North Anna 3 COLA

Discussion Slides for Proposed COLA
Changes – RAI 03.07.04-2
NA3 Operating Basis Earthquake
NRC Open Items Teleconference
July 10, 2014

RAI 115: Question 03.07.04-2 Plant-Shutdown OBE

Schematic Example (Not included in the FSAR)

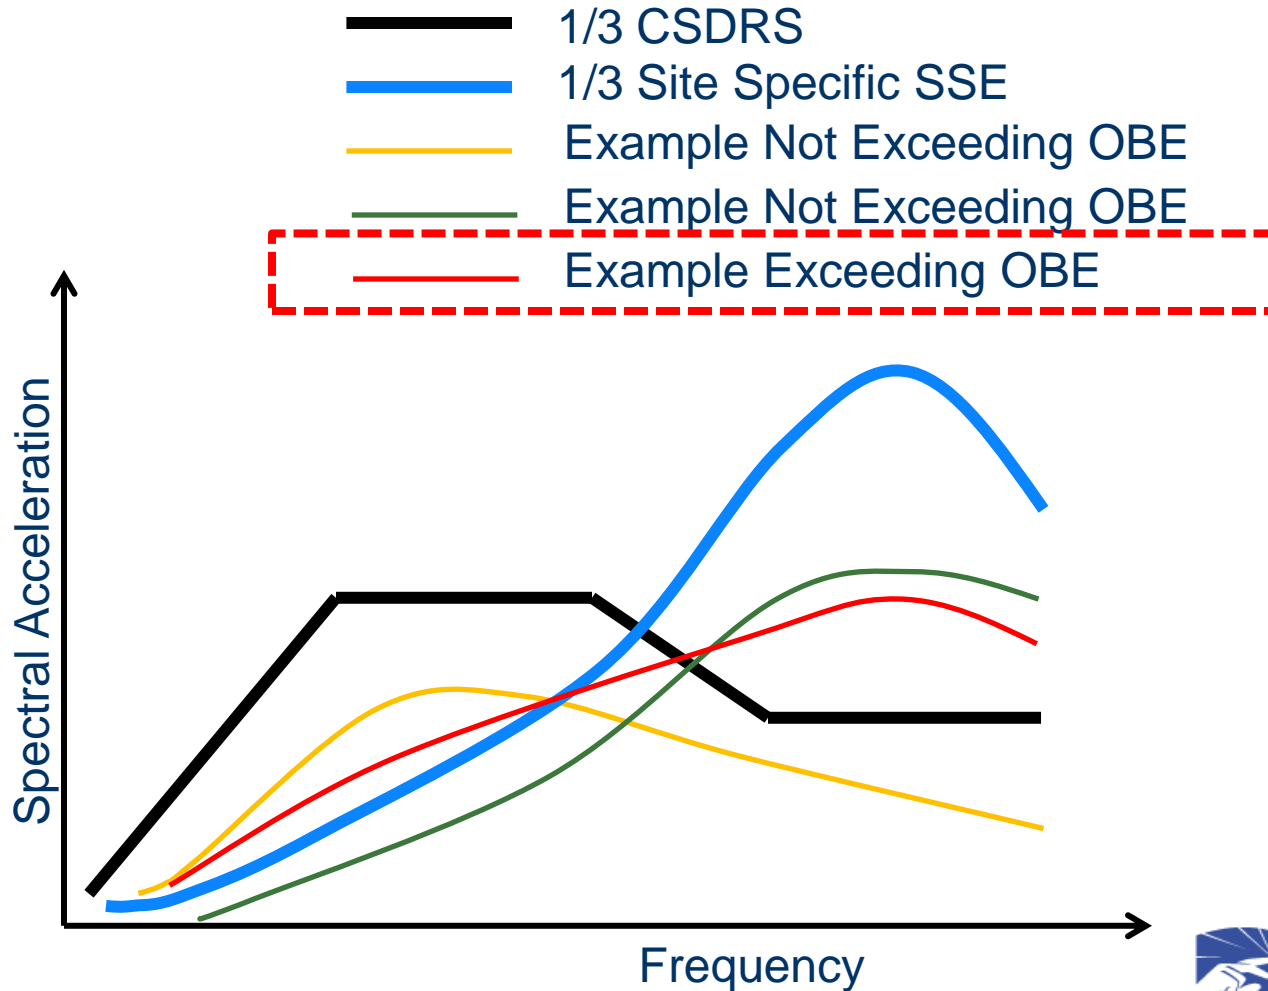
Exceedance of the response spectra (a) and (b) is evaluated independently (i.e., an envelope of the two response spectra is not used). For example, a response spectrum that exceeds (b) at a low frequency and exceeds (a) at higher frequencies, but falls below the envelope of the two response spectra is considered as exceeding the OBE; thus requiring shutdown of the plant as discussed in FSAR Section 3.7.4.4.
